Service Bulletin

P0928-SB-R3

1.2. Reason

Figure 2-1: Typical Cargo Hook Installation

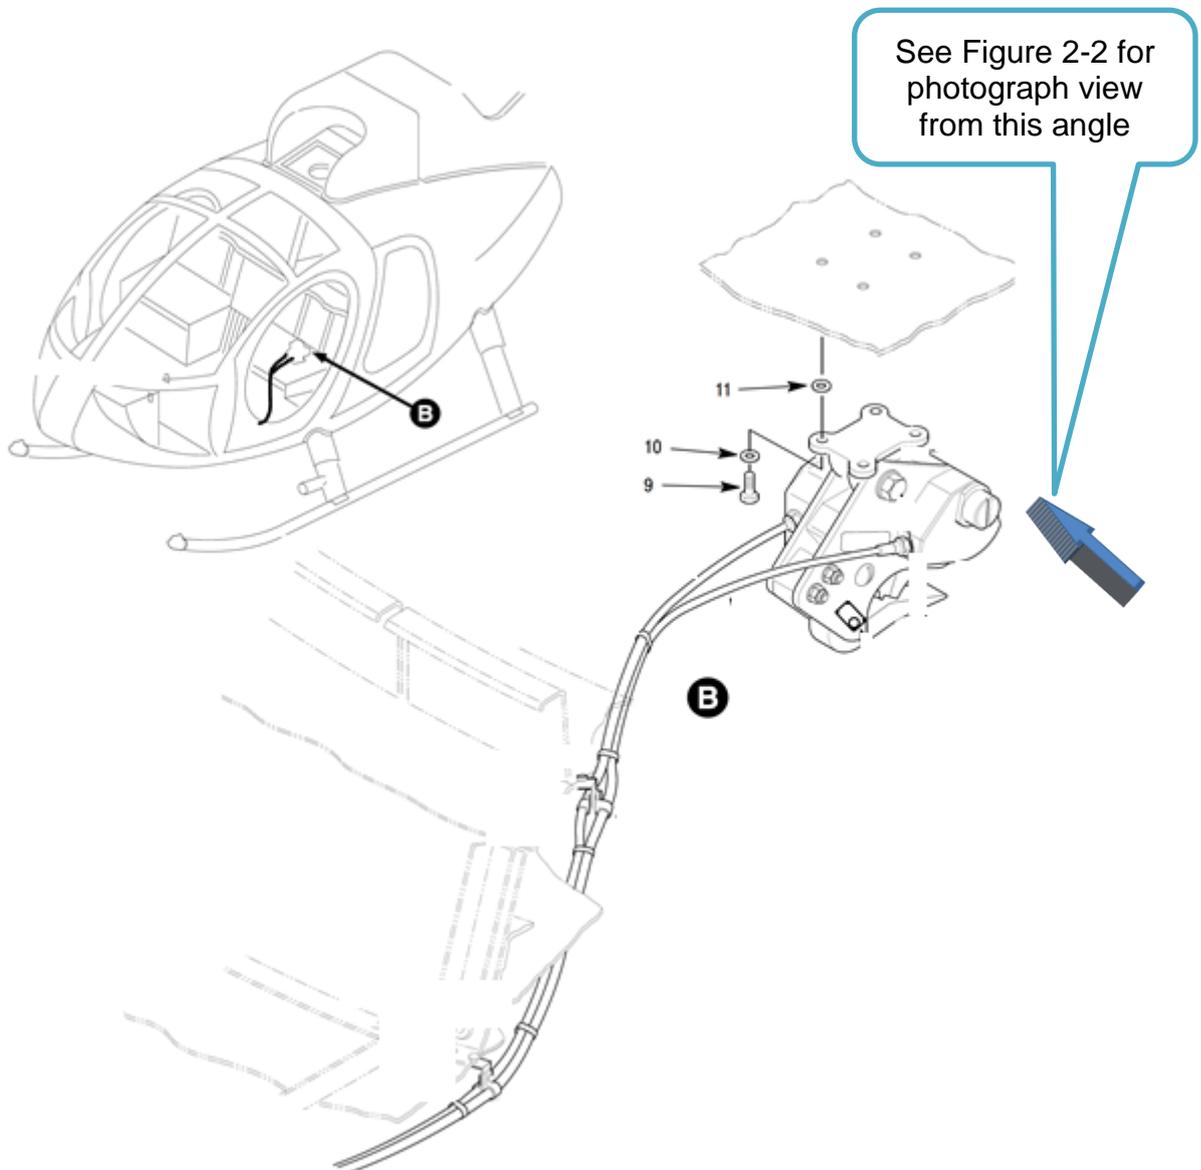
The hook provided by MDHI is attached using bolts NAS1304-6 (Qty 4, item 9 in Figure 2-1) and washer AN960-416L (Qty 4, item 10 in Figure 2-1).

Figure 2-2: Inboard fitting of DG500 Cargo Pod

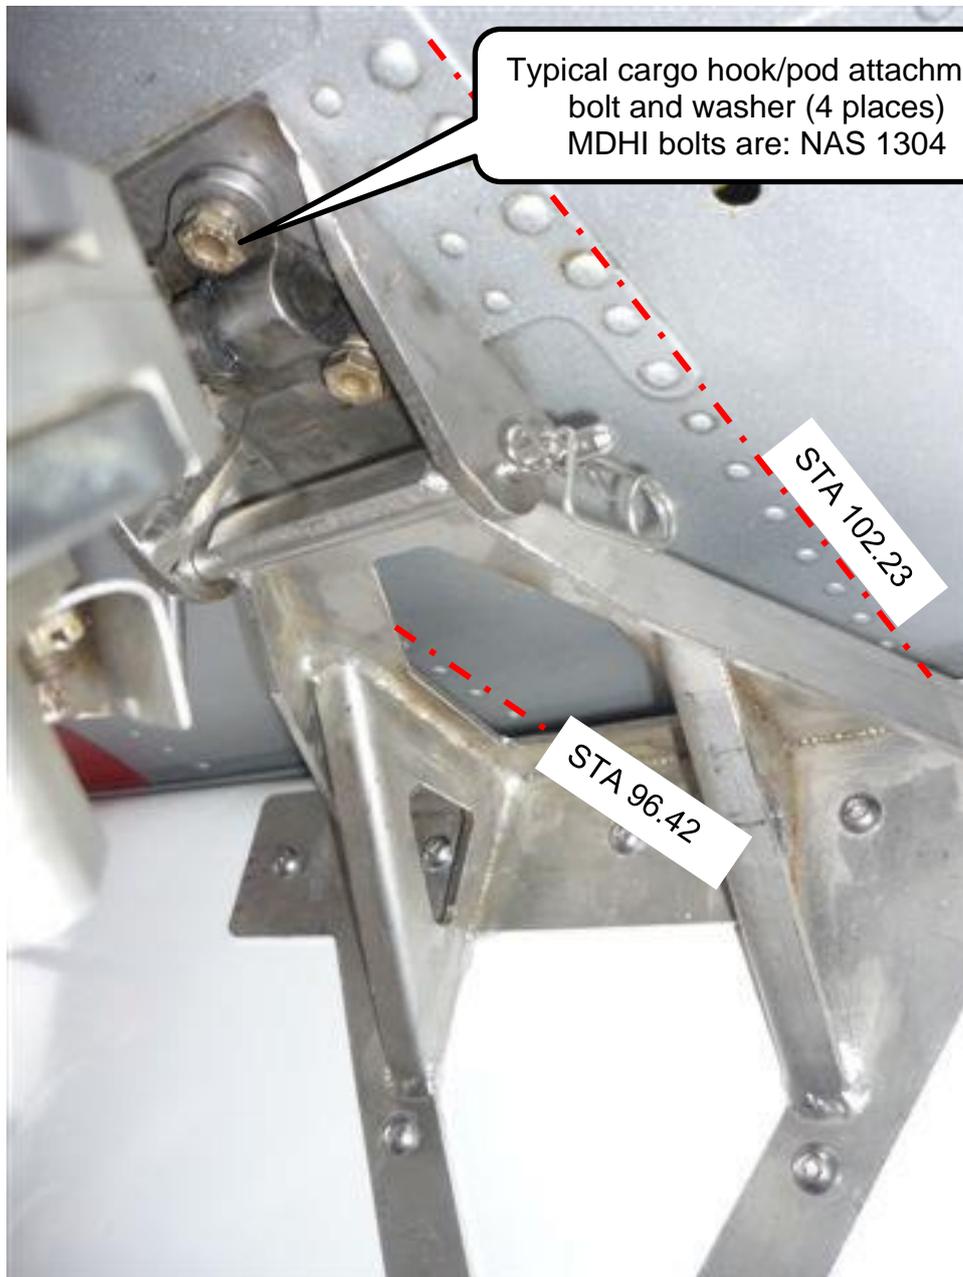
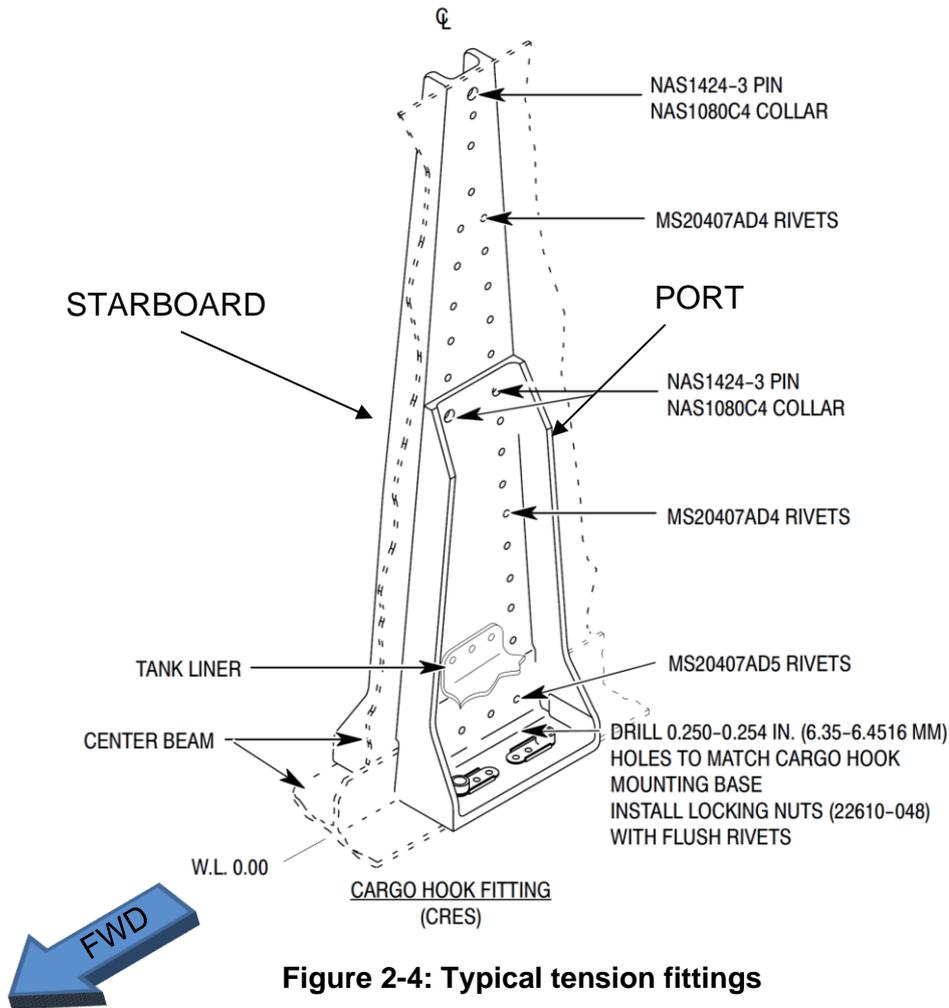
Modification Bulletin MB 25.00.129 installs the cargo pod with an inboard fitting that shares the hard point attachment with the cargo hook, see Figure 2-2. The fitting is fabricated from 5 mm thick stainless-steel sheet, which required replacement of the attaching bolts for a longer dash length.

Cargo attachment bolts (see Figure 2-2) are replaced in accordance with § 3.3 step 1 of MB 25.00.129, without explicit specification of bolts or length.

Identify the cargo hook/pod attachment bolt type (refer Figure 2-2). This should be clearly visible on the bolt head.

- 1) Inspect cargo hook/pod bolts.
- 2) If NAS 1304 bolts are installed with correct length (refer note 1 below), continue to § 3.2.
- 3) If alternative fasteners used, replace immediately with NAS1304 or NAS6604 with correct length (refer notes 1 and 2 below) and report the fasteners being replaced using Form NT10 attached.

Note 1: In order to establish the correct bolt length, i.e. minimum 2 clear threads upon assembly of the pod bracket, hook bracket (if fitted) and washer:
